BCAC Meeting #12

Date: 12-22-2020

## BCAC Egress Item 6 corridor continuity – 6 proposals

# Proposal 1 – Elevator hoistway and door protection

Diagram for which walls are fire partitions, smoke partitions or smoke barriers

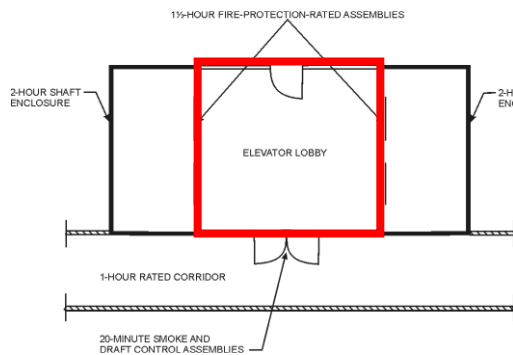
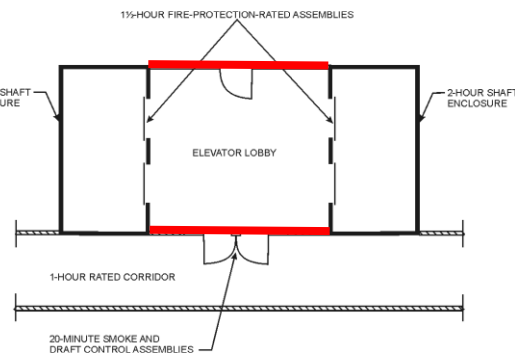
Reason: The intent of this proposal is to clarify lobby protection requirements – which walls are fire barriers, fire partitions or smoke barriers. This will also clarify what requirements are applicable for the elevator hoistway doors vs. the doors in the other walls of the lobby protection. The current language is inconsistent for the locations where elevator lobbies are specified.

This protection of elevator lobbies is a combination of the elevator hoistway and exit stairway (direct access to a stairway is required for fire service an occupant evacuation elevator lobbies) shaft enclosure/fire barriers and the fire partitions or smoke barriers required for lobbies (405.4.3, 3006.3, 3007.6.2 and 3008.6.2) The intent of new 708.4.1 and revised 709.4.2 is to clarify that the fire partitions/smoke barrier criteria is not applicable to all the walls of the elevator lobby since the vertical shaft/fire barrier protections is adequate. Fires typically happen in the occupied portions of the buildings, not within the elevator shaft or the stairway. In addition, in situations where an elevator lobby is provided, the elevator shafts are double protected from smoke intrusion from a fire on the floor.

Provisions for horizontal continuity are addressed for smoke barriers that surround elevator lobbies or areas of refuge. The same horizontal continuity should be addressed for elevator lobbies enclosed with fire partitions in Section 3006.3 Item 1 or smoke partitions in Section 3006.3 Item 2. The movement of ‘smoke barrier wall’ just assures a minimum fire resistance rating. The last sentence in 709.4.2 is not needed with the clarification of which walls meet which requirements in Chapter 30.

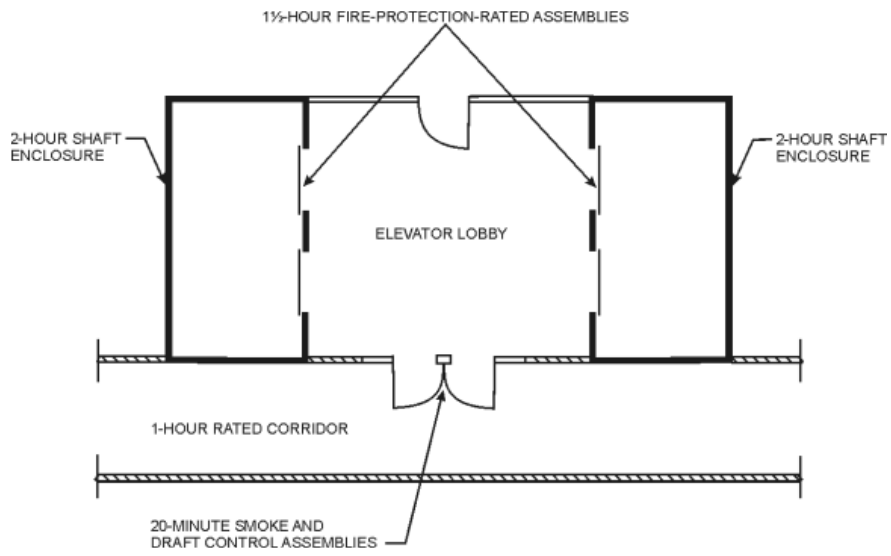
Reason: The intent of this proposal is to allow for two and three story Group R and Group I-1 buildings that do not have to have elevator lobbies to not have smoke and draft control at the doors. Even with sprinklers, these buildings have fire resistance rated corridors.

Elevators are within vertical shafts and are sent to fire barrier protection requirements in Section 712.1.1, 713.14 and 3002.1. Section 707.6 in fire barriers references Section 716 for opening protection of all openings, which would include door through the shaft to allow entrance into the elevator car. Elevator car doors often open directly into a rated corridor, so Section 716.2.2.1 is applicable to those elevator doors.

The new exception 5 in Section 716.2.2.1 is to allow for elevators in low rise building to not have to meet the smoke and draft requirements of opening protectives in corridors. While many elevator hoistway/vertical shaft doors are tested and labeled for the 1-hour or 1<sup>1</sup>/<sub>2</sub>-hour fire resistance rating (see Section 716.2.1), very few, if any

of the doors typically sold in the United States will also meet the smoke and draft requirements (see Section 716.2.2.1.1) that would allow them to open directly into a fire-resistance-rated corridor.

Current text literally results in elevator lobbies or other protection in front of the elevator doors in all rated corridors. There would not be significant stack effect for the movement of smoke with this minimal allowance. The code currently allows other floor vertical openings in Sections 712 and 1019.3 for four stories, so how is the elevator shaft more of a hazard? This allowance would make these buildings then require elevator lobbies/elevator opening protect at the same point, thus coordinating Section 716 and 3006.
